Near-Infrared Tip-Tilt Sensor Preliminary Design Review

KAON 863
April 25, 2011

Response to SDR Review Committee Report

1) Compressor location

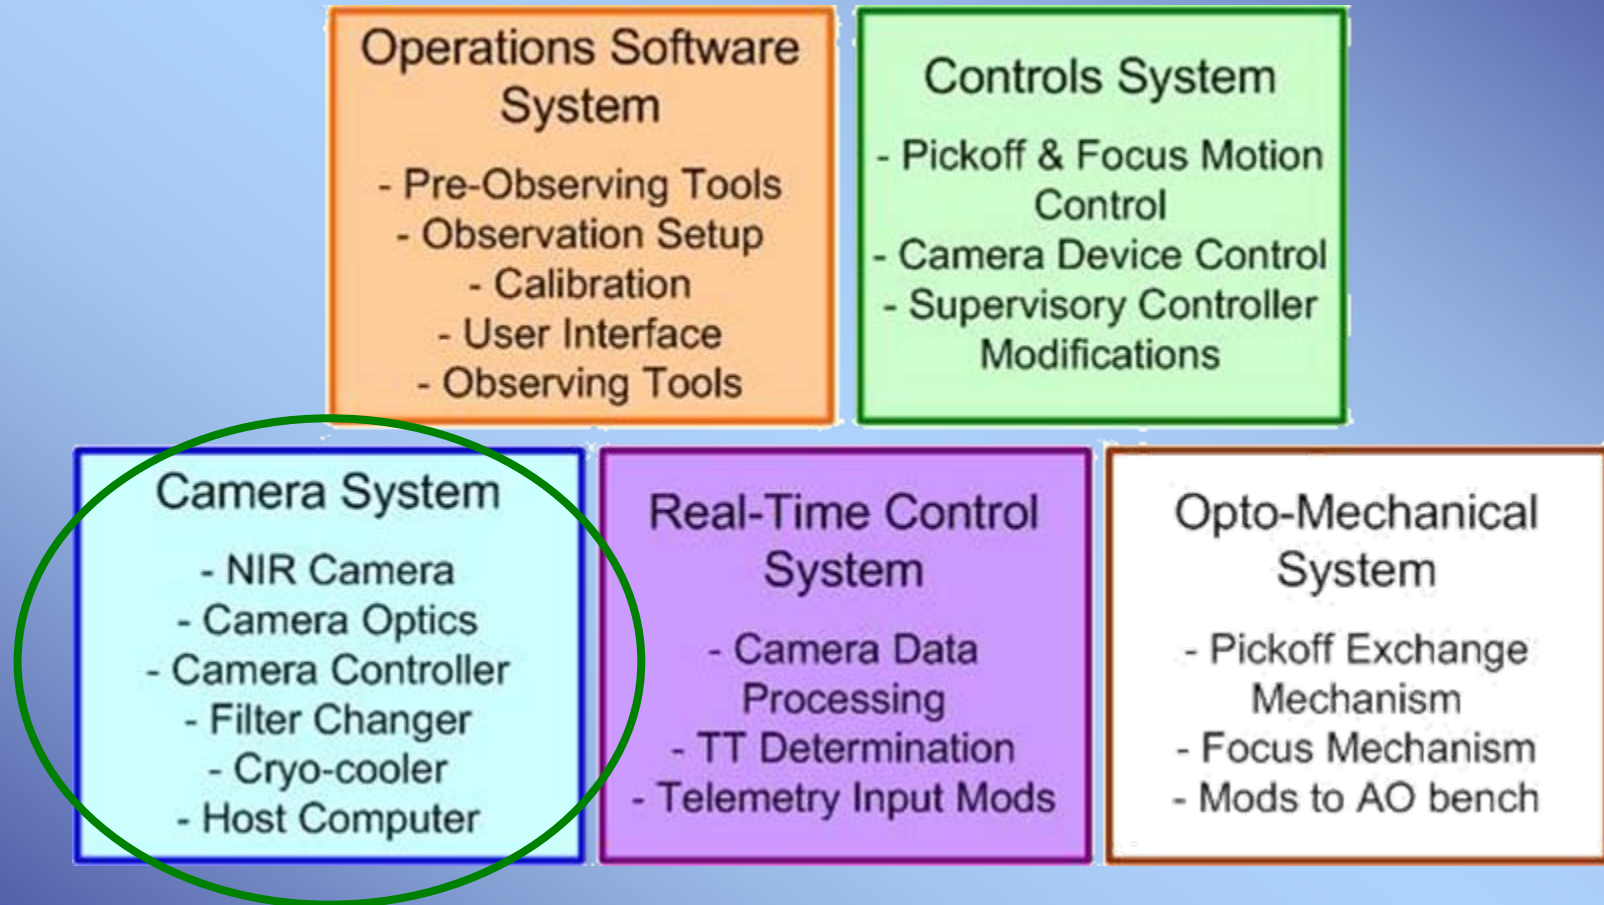
- Trade study leading to the current design
- Including the risk of vibration transmissions to the AO system

- Compressor location largely driven by safety concerns in the event of the use of a flammable gas (less volume) plus the cost of procuring & installing the lines.
- Anecdotally can't feel vibrations when standing next to compressor (RS estimate $<10\times$ the noise of a computer fan).
- Compressor is suspended from ceiling & sits on a vibration isolated pad.
- Vibrations through the hoses, if any, are damped by appropriately mounting hoses & having bends in the hoses.
- If vibrations become an issue we can move the compressor to the machinery room.

MASS BREAKDOWN

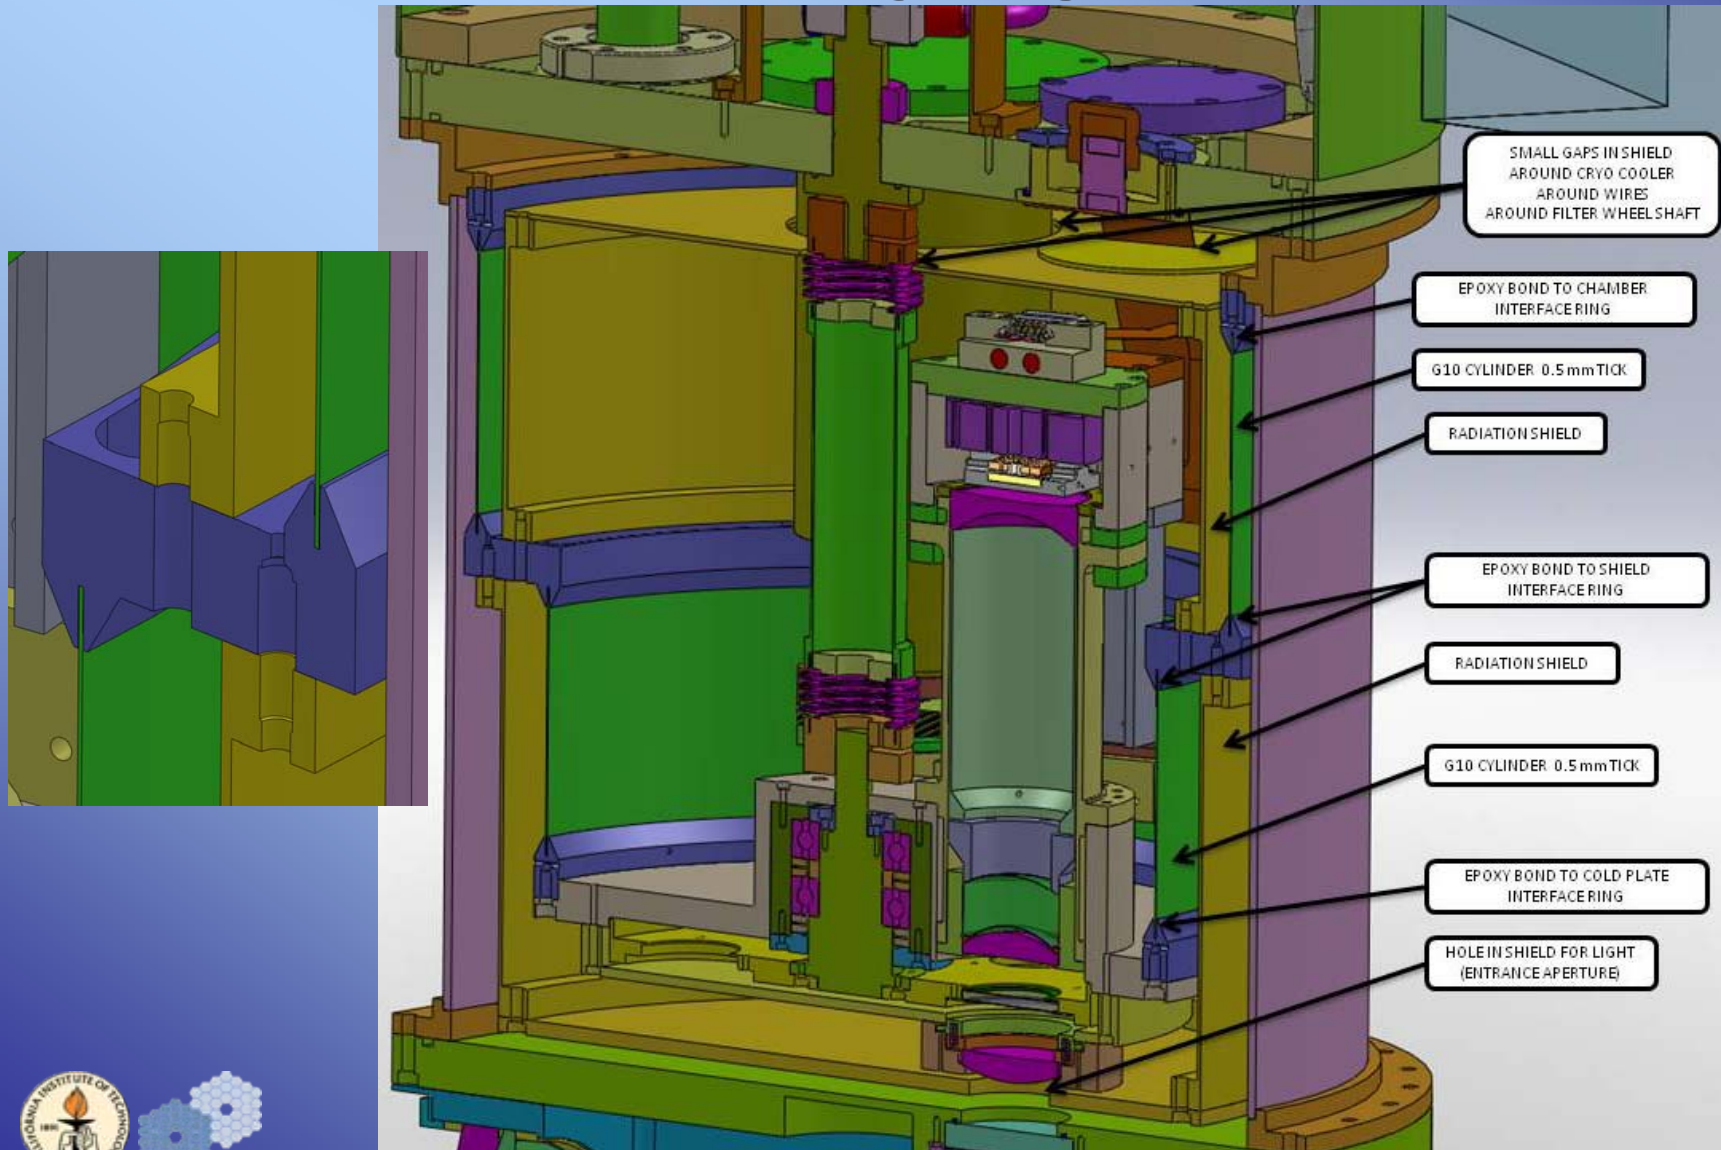
RIQ-CBO3: Is there a plan to do a flexure analysis of the TRICK system during DD and also to check the impacts on AO bench?

Much heavier than originally estimated:

- Cryostat and base, no light weighting = 103 lb
- With light weighting = 85 lb
- Analysis in DD phase is planned to determine if cost of light weighting is justified, etc.

Filter Pupil Mounting

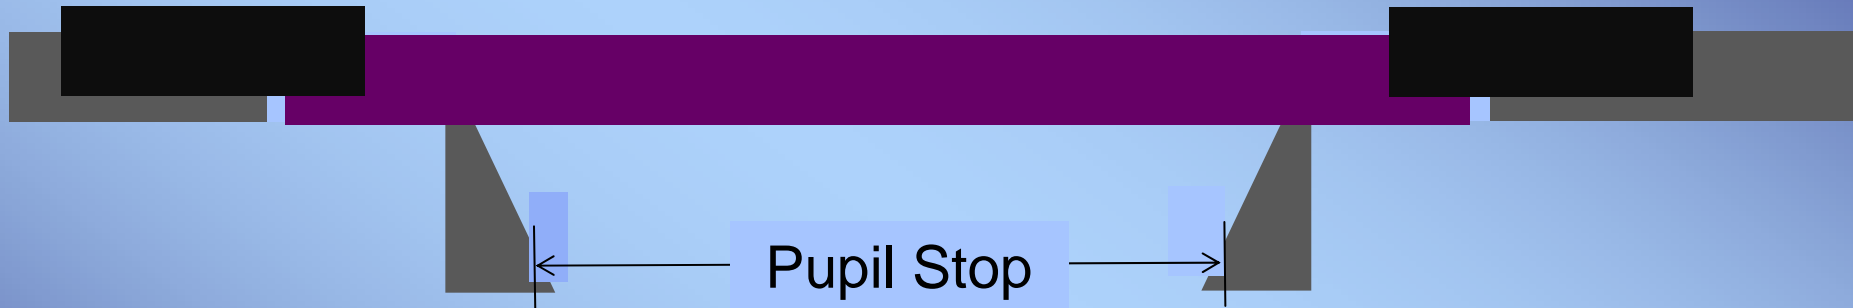
RIQ-RDC6: It's not clear to me how the filters/pupil stops will be mounted? What material will be used. Is there any mechanical design work done yet for the filter holders/pupil masks. I'm concerned about restraining the filters without possible coating damage to the filters.

- Contact made outside optical path.
- Precise pupil stop machined into filter wheel itself, for best repeatability and minimal radial position variation from filter to filter.
- Tangential position errors will be corrected with drive system.

THERMAL LOAD & COOLING TIME

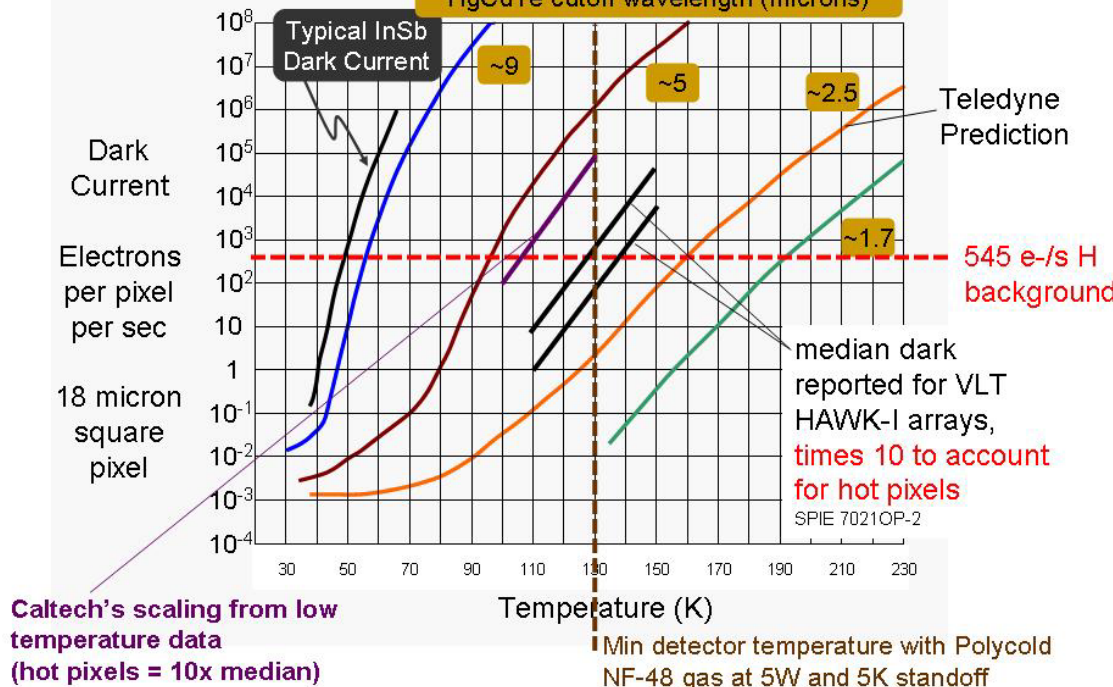
RIQ-BCO3: Have you performed a cool-down analysis and estimated the time for cool-down and warm-up?

- Equilibrium thermal load on cryocooler < 4 W
 - 0.45 m² radiation shield : < 2 W
 - 0.0009 m² gaps have unit emissivity: 0.02 W
 - Radiation through entrance window: 0.4 W
 - Conduction through G10 Shield support: <0.25 W
 - Conduction through G10 drive shaft: 0.05 W (allocation)
 - Conduction through electrical wires: 0.15 W (allocation)
 - Heater power allowance: 1 W
- Cryotiger with high performance head and PT14 gas: 15 W peak
- Cooling time currently ~36 hr, will be reduced to < 24hr
 - by light-weighting cooled mass from 6.5kg to ~4kg.
 - In DD phase will adapt existing numerical models to provide better estimate: may permit cost saving on low emissivity coatings.
- Warming time = 4 hr: active heating enforces 1K/min slew rate.
 - ~80 W heater power from 2nd servo loop on Lakeshore controller

4) Software

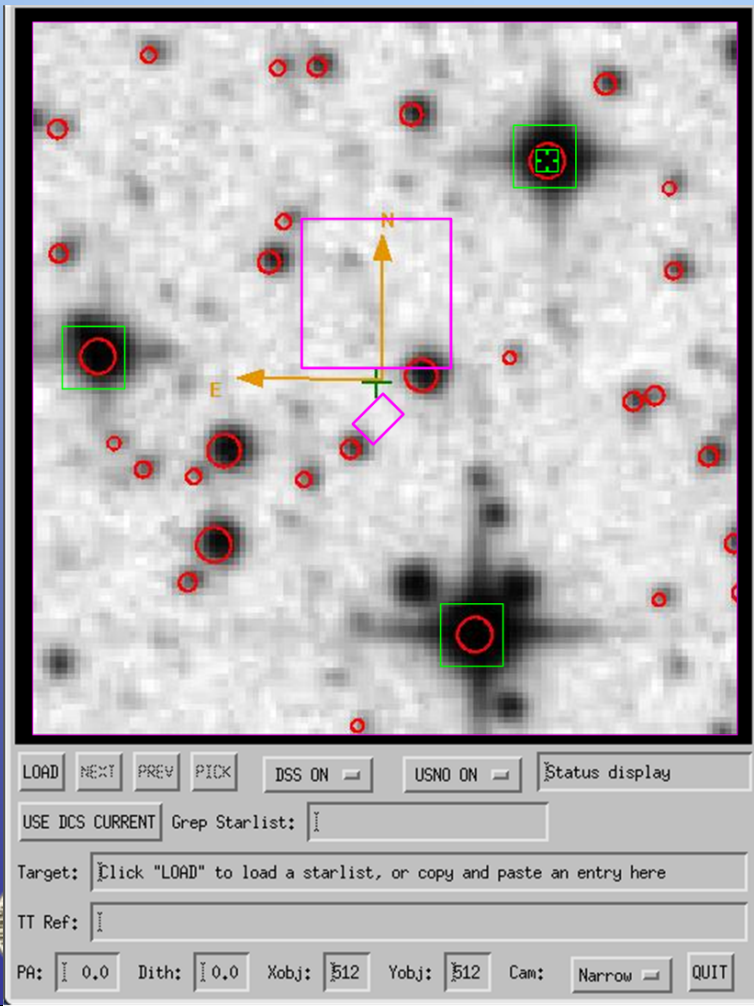
- Why not use existing tools such as MAGIQ for adjusting the guide star selection during observations and for centering the science object?

- Sorry for confusion on this topic
 - due to incomplete updates of the O OCD & PDM
- MAGIQ/ACAM will primarily be used for acquisition
- NIR TTS camera only used as a backup if IR field ID required
- Neyman, Lyke, Kwok & LaVen concluded this was a workable solution considering:
 - Still need a visible star for LBWFS
 - Use visible star to adjust telescope pointing with ACAM/MAGIQ
 - Catalog position good enough to assign initial ROIs (16x16, 8x8)
 - Determine if the NIR star is usable (not a double, galaxy, etc.) by closing tip-tilt loop & monitoring performance with the NIR Status tool
 - NIR TTS full frame image display provides IR field ID if required
